(MM3-CBS-REL-PYL)

“Procurement, Supply, Installation, Testing and Commissioning of various Power Supply works including associated Civil works, required for diversion of 220 kV and 33 kV Transmission Lines along with the Transmission towers belonging to M/s Reliance Infrastructure Ltd. in Aarey depot area for Mumbai Metro Line -3”

Addendum No. 1

Date: 27th April 2017

DRAWING NO. :- MM3-CBS-REL-PYL/019

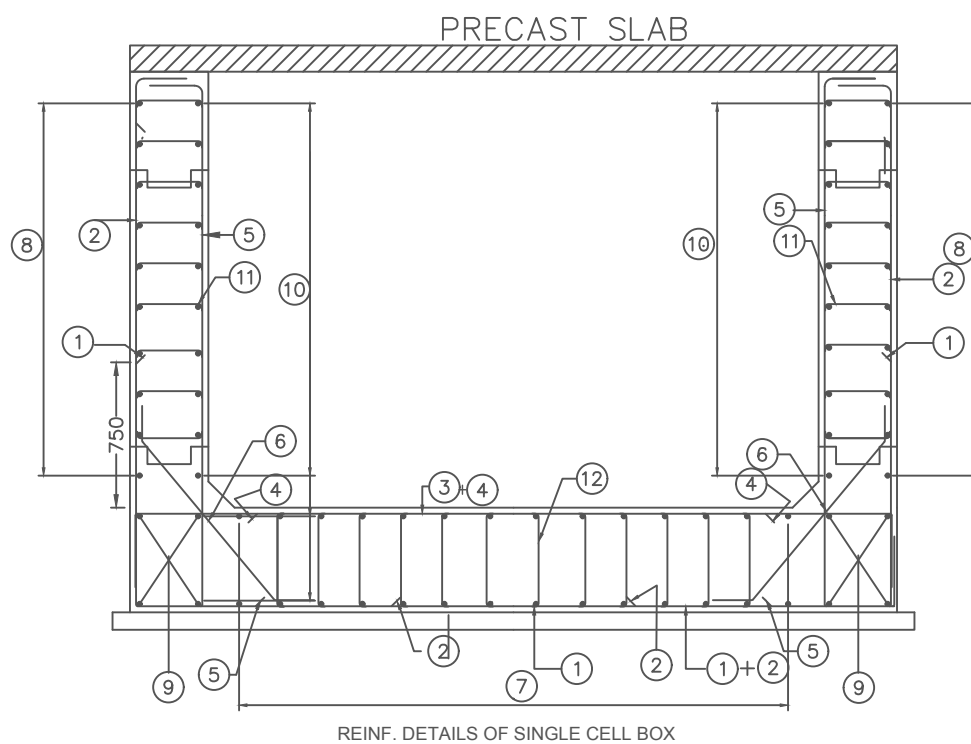
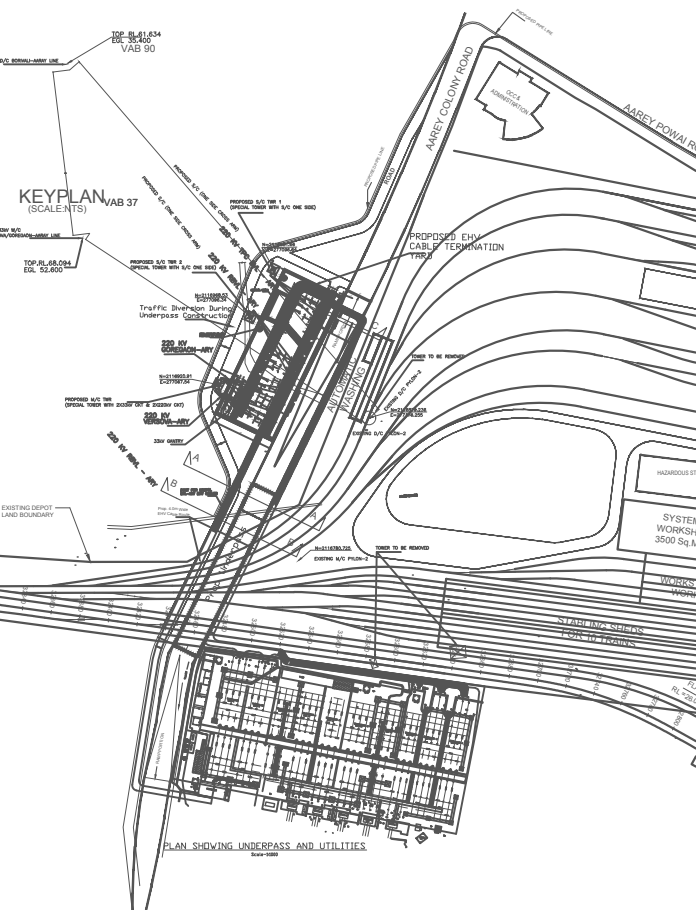
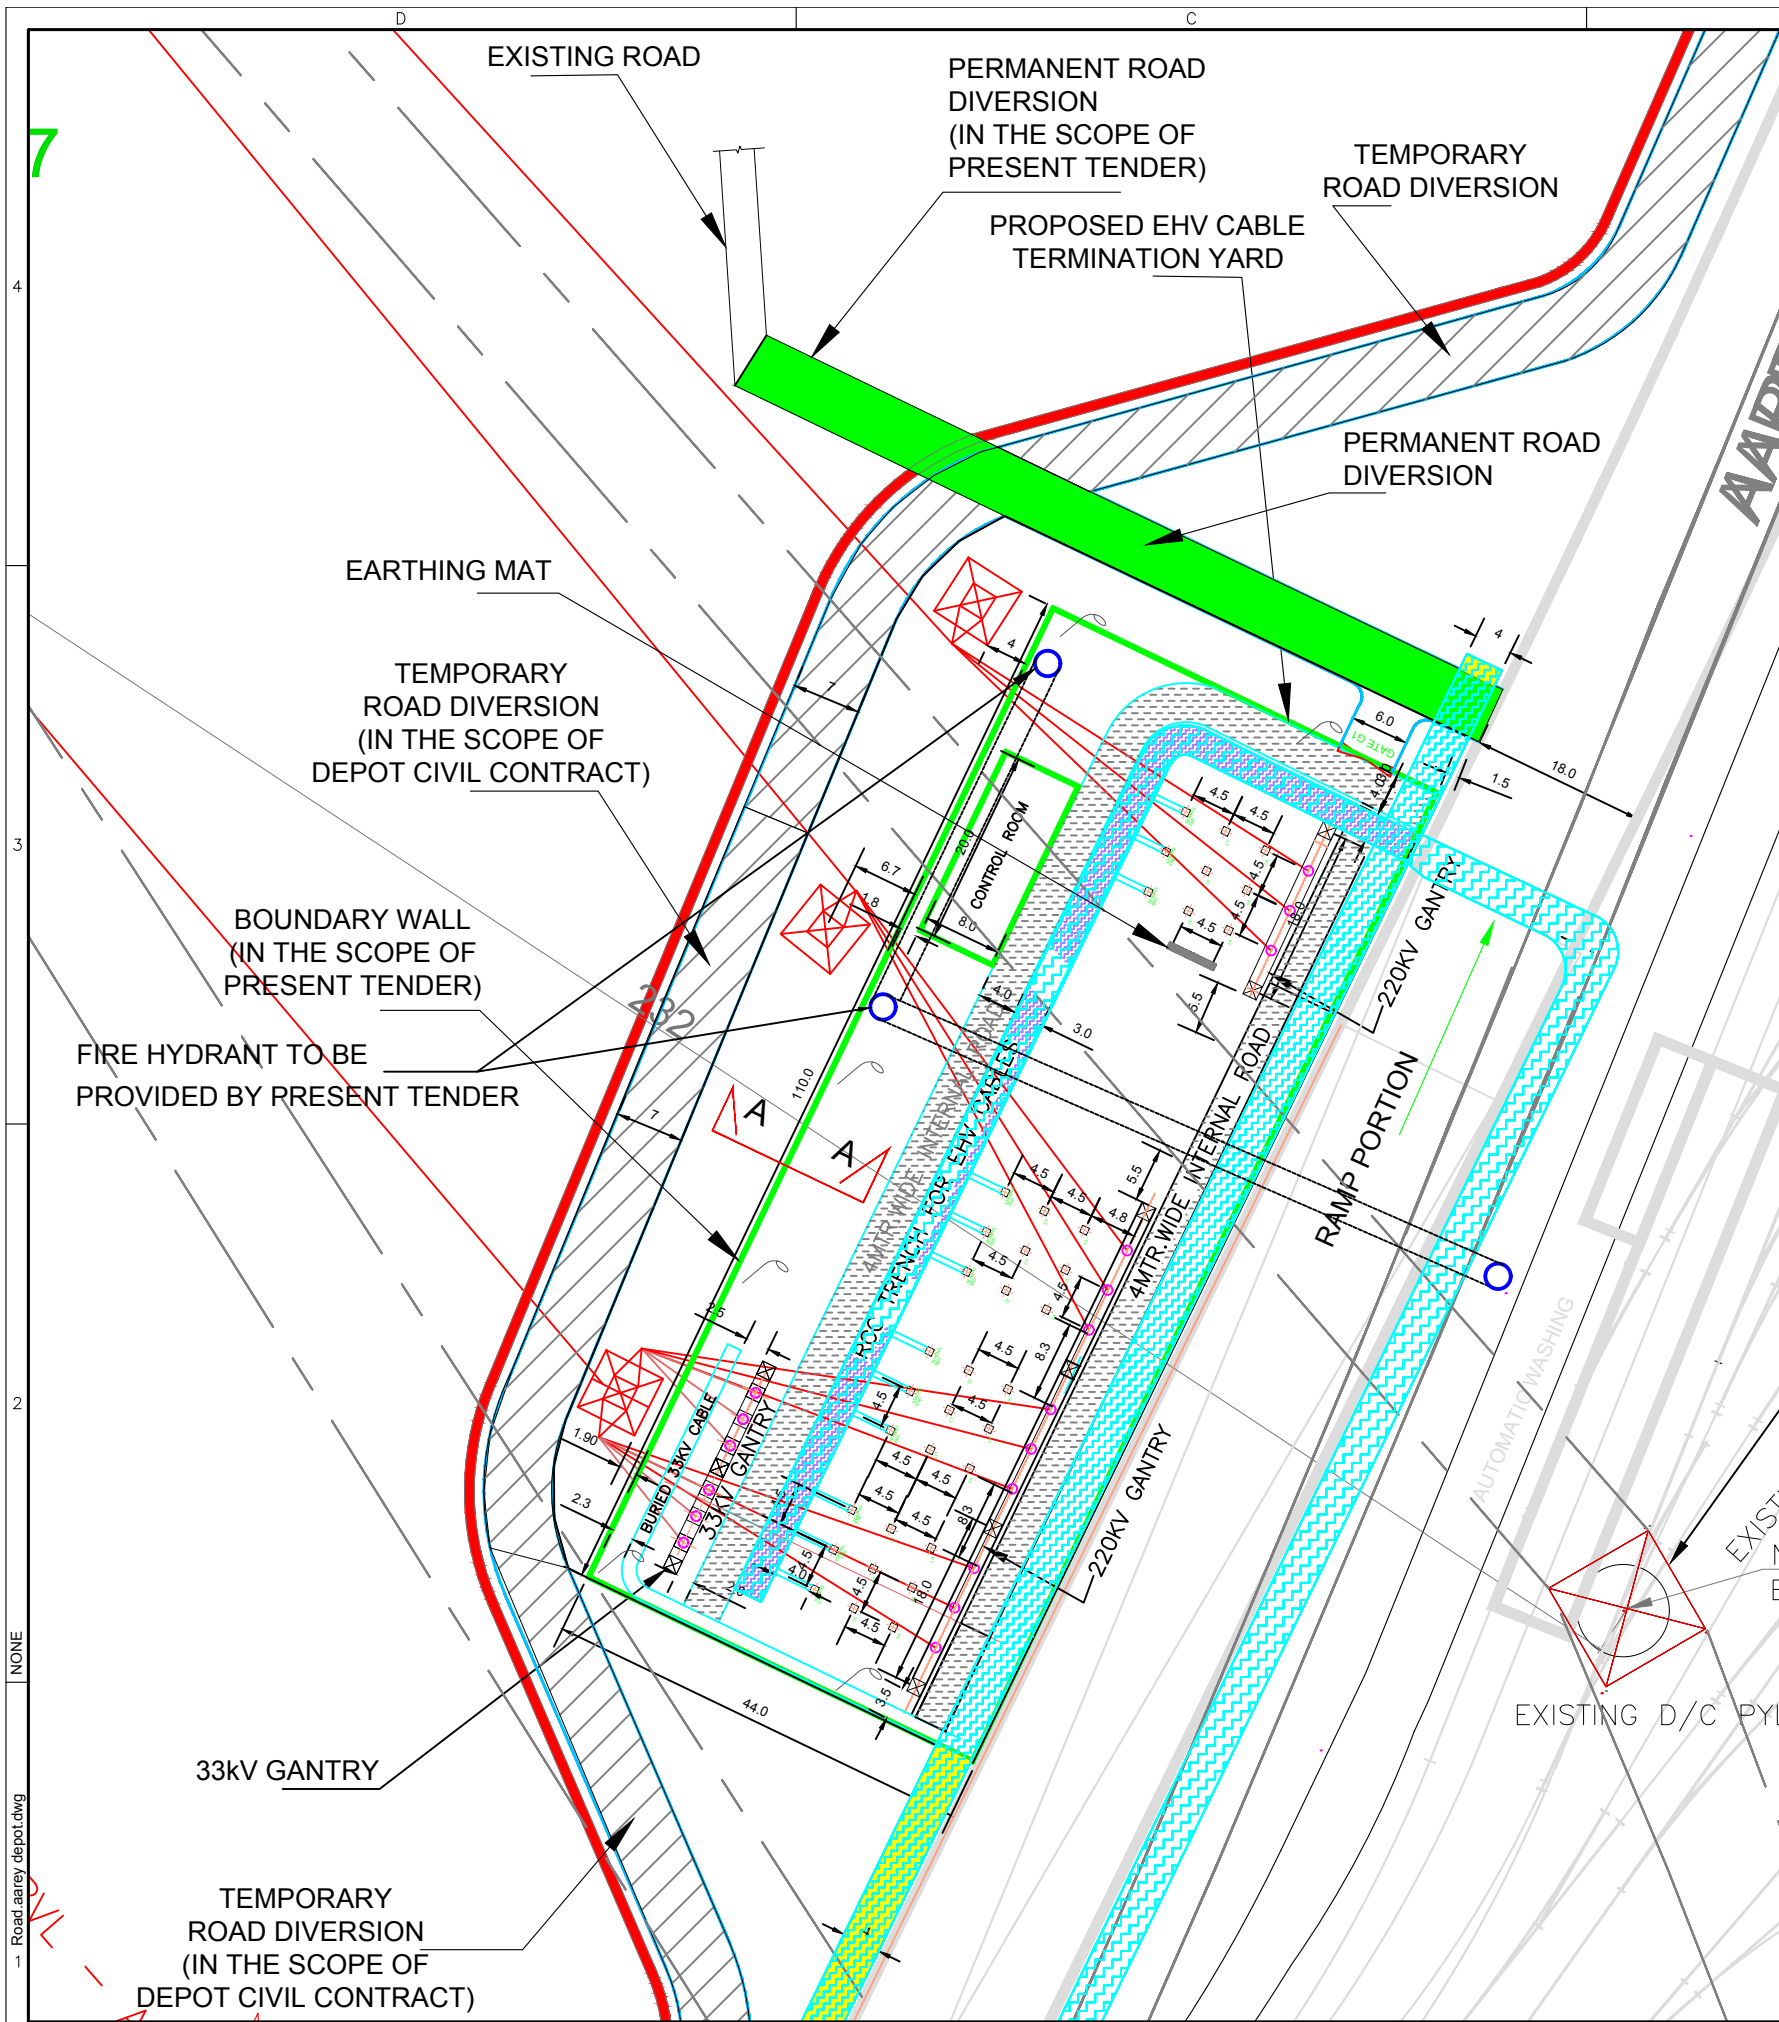
D				
C				
B				
01	27.04.2017	VP	KLS	PRECAST SLAB MODIFIED.
REV.	DATE	PREP.	APPROVED	DESCRIPTION
